# Improved Technical Specifications

## Dresden Station

Volume 5:  
Section 3.4 and Section 3.5

**ComEd**

Figure 3.4.9-1

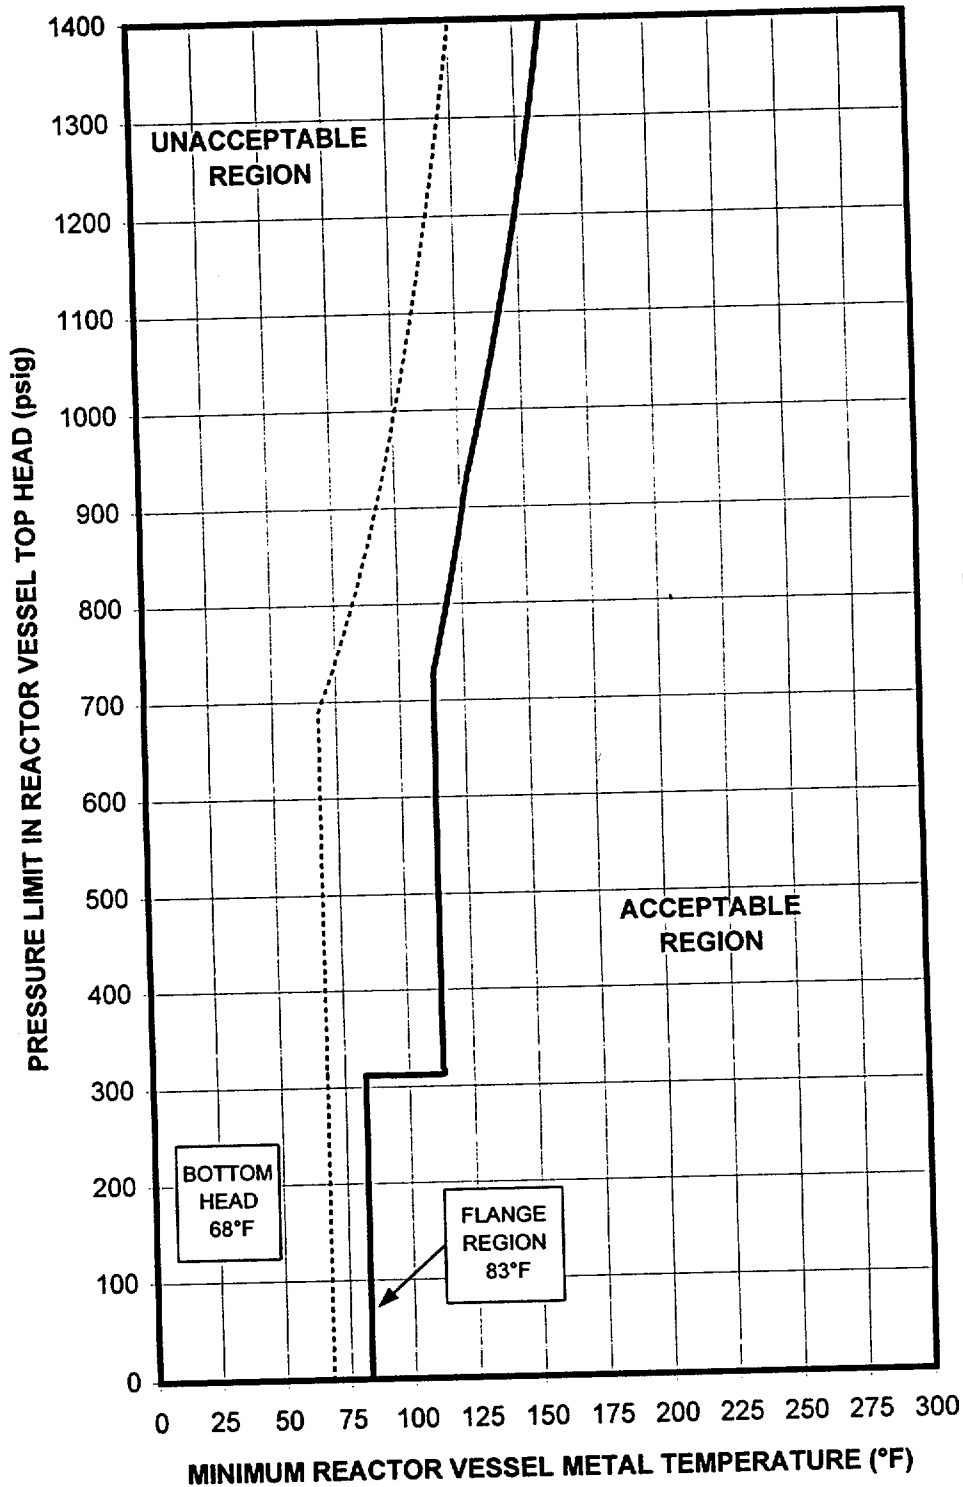
FIGURE 3.6.K-1

HEATUP/COOLDOWN  
RATE OF COOLANT  
 $\leq 20^{\circ}\text{F}/\text{HR}$

Figure 3.4.9-1 (Page 1 of 1)  
Non-Nuclear Inservice Leak and Hydrostatic Testing Curve  
(Valid to 32 EFY)

Figure 3.4.9-2 (Page 1 of 1)  
Non-Nuclear Heatup/Cooldown Curve  
(Valid to 32 EFPY)

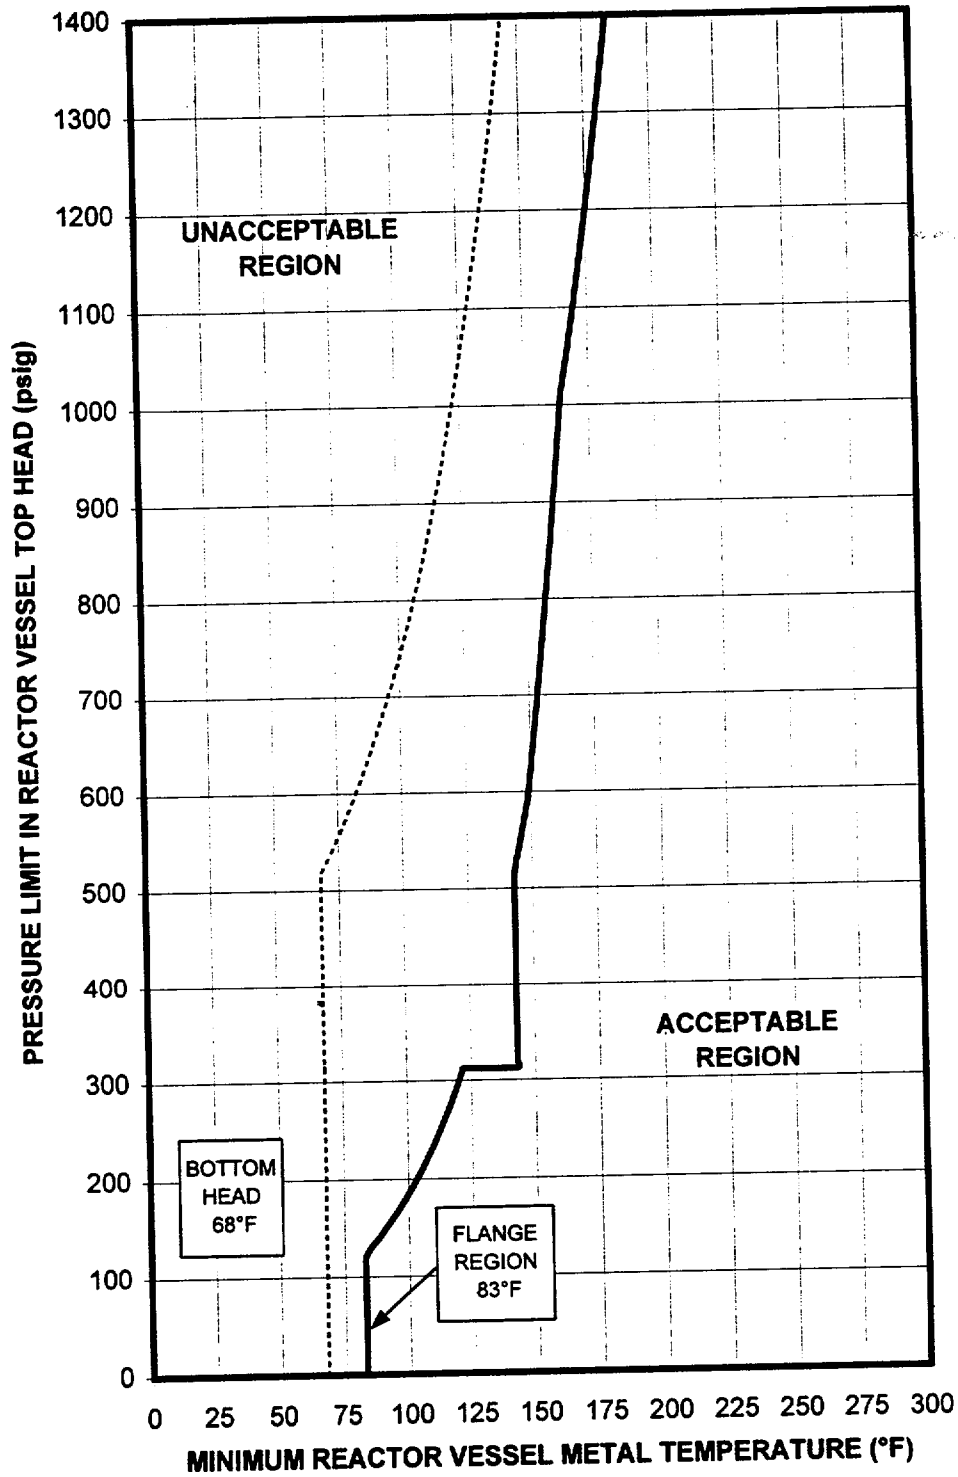
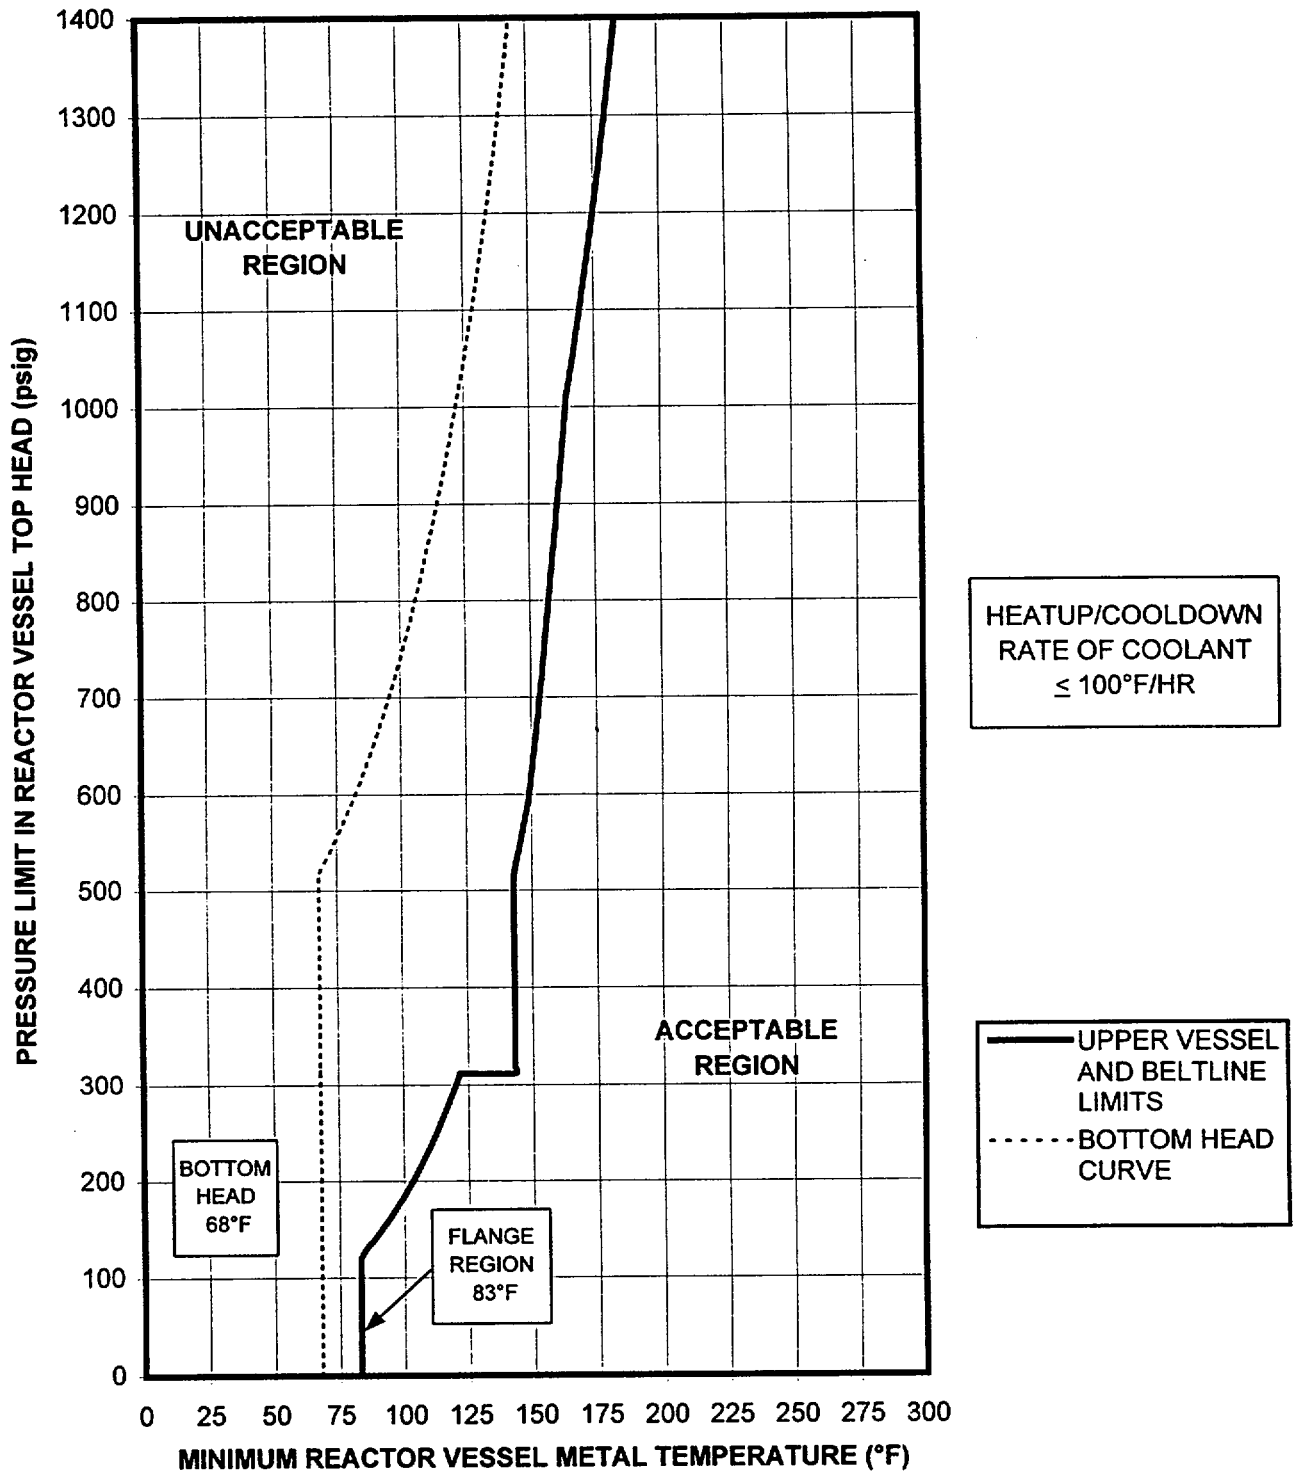
FIGURE 3.6.K-2

<Fig.  
3.6.K-2>

Insert Figure 3.4.9-2

Figure 3.4.9-3 (Page 1 of 1)  
Critical Operations Curve  
(Valid to 32 EFPY)

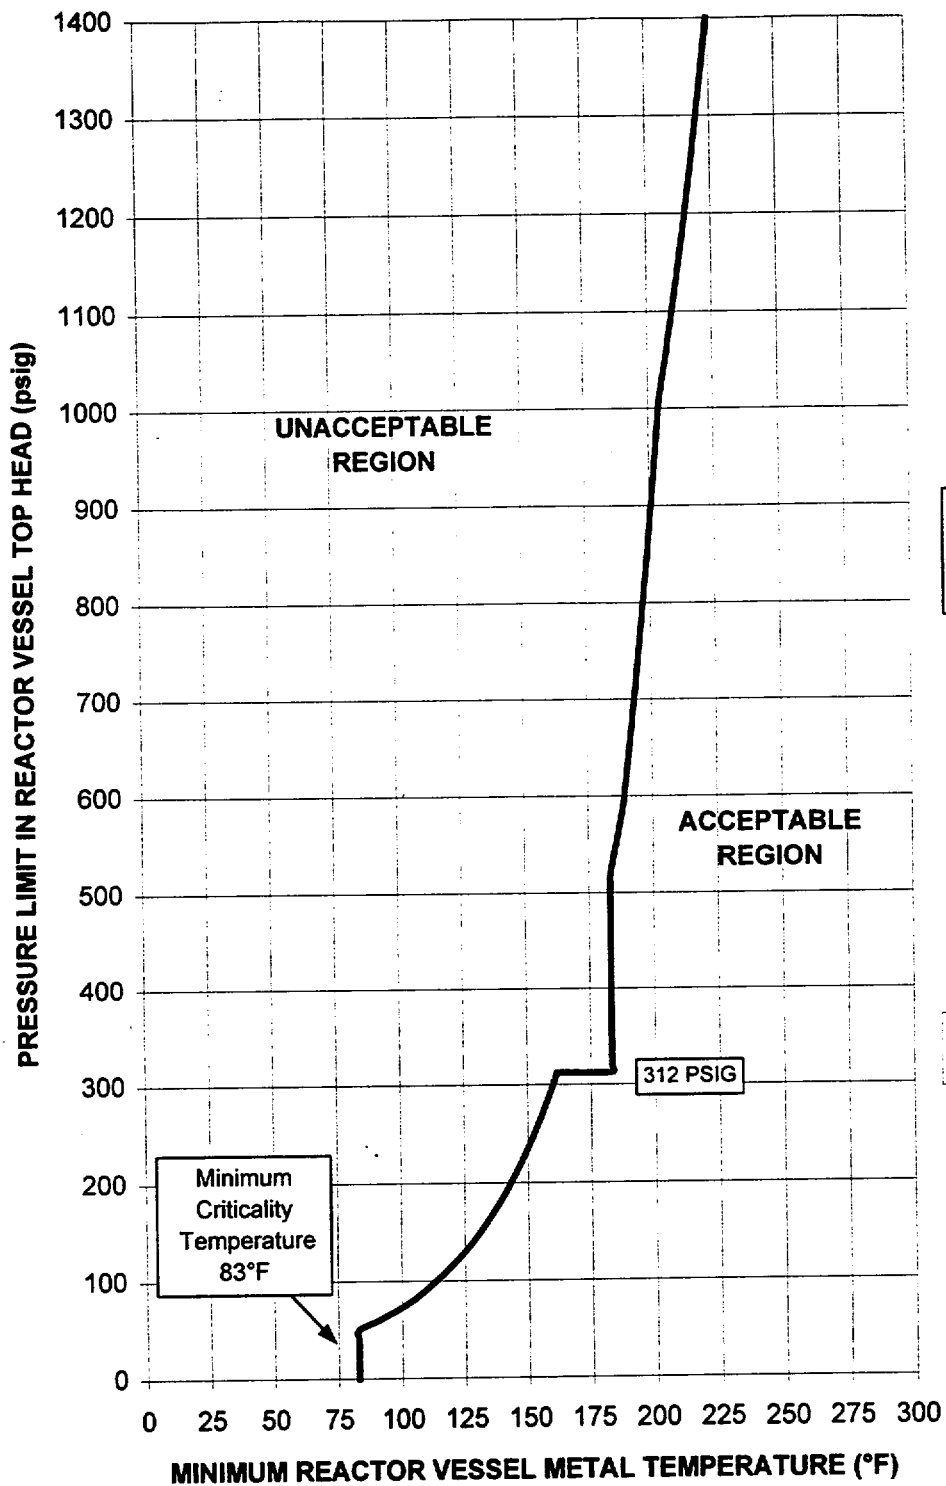
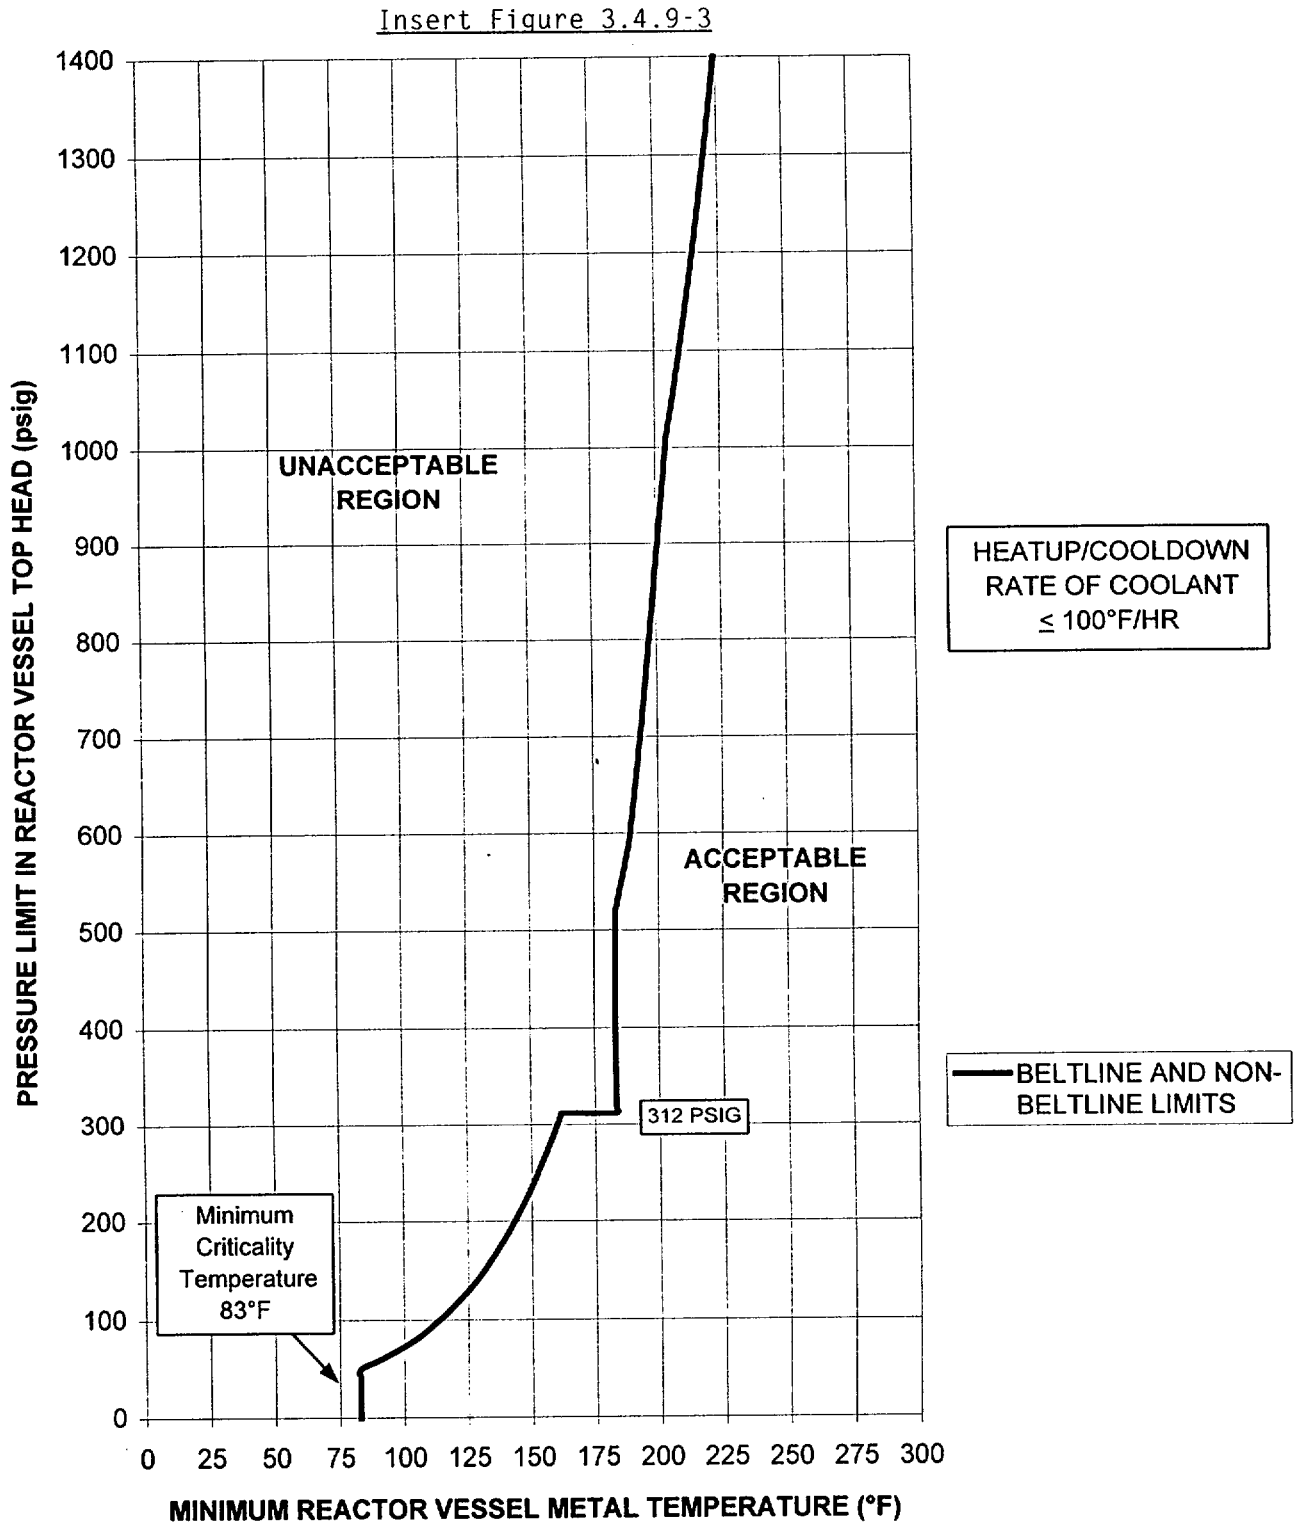
FIGURE 3.6.K-3

HEATUP/COOLDOWN  
RATE OF COOLANT  
 $\leq 100^{\circ}\text{F}/\text{HR}$

<Fig.  
3.6.K-3>
